MELBOURNE METRO RAIL PROJECT ENVIRONMENT EFFECTS STATEMENT
INQUIRY AND ADVISORY COMMITTEE

MMRA TECHNICAL NOTE

TECHNICAL NOTE NUMBER: 061
DATE: 26 September 2016
PRECINCT: CBD North and Western Portal
EES/MAP BOOK REFERENCE: N/A

SUBJECT: Response to the 'Matters for further consideration and/or clarification' request dated 12 September 2016

Figure 1 Extracts from Geological Long Section Drg 1525532-331-R-003 with plan showing current approximate surface levels

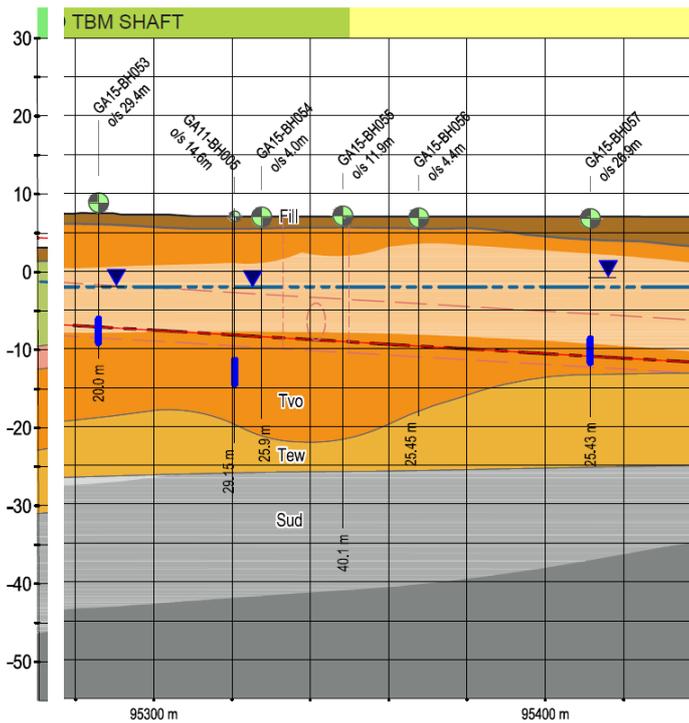
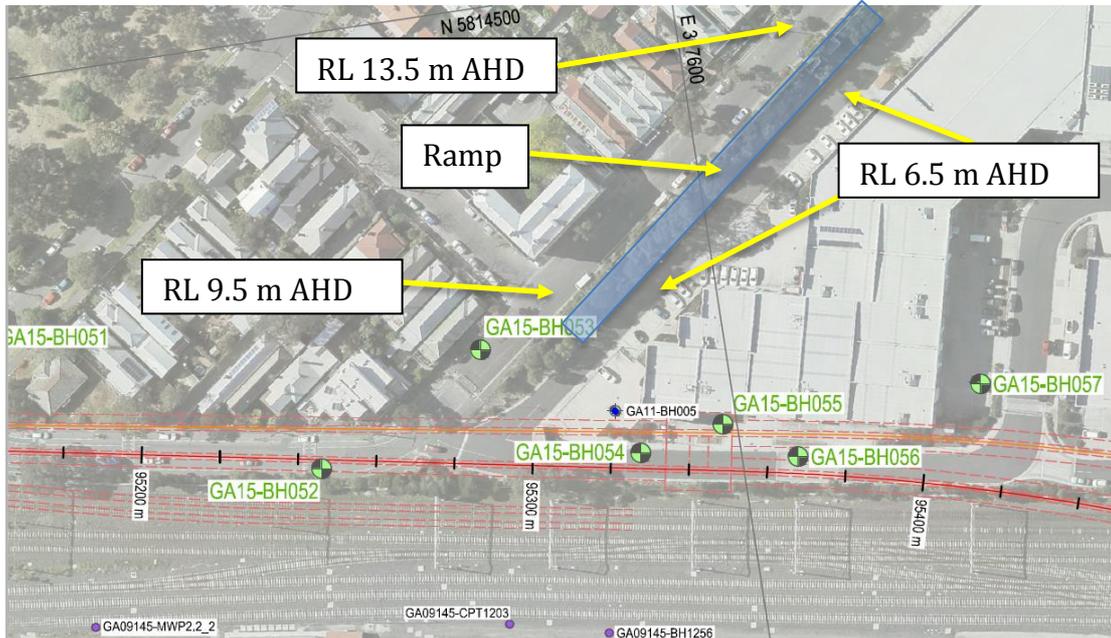
Whether the increase in consolidation is likely to be caused by the construction of the possible Lloyd Street temporary access (earthen) ramp and whether consequent ground movement effects on nearby residential and commercial properties has been assessed.

5. At Tennyson Street, the ground conditions adjacent to the Melbourne Metro rail alignment comprise a layer of fill overlying basalt of the Older Volcanics. Groundwater has been encountered at levels approximately 7 m below the surface level of the business estate. These aspects are shown in Figure 1 in Attachment A, which consists of extracts from the Interpreted Geological Setting EES Summary Report – July 2016 Update. While no investigations have been conducted for the Project towards the northern side of the business estate, the regional model indicates that ground conditions similar to those adjacent to the rail alignment extend to the north.

6. Given these conditions, excavation into the existing slope between Tennyson Street and the business estate would be expected to have no effect on the groundwater table, and therefore there would be no consolidation due to drawdown of the groundwater.
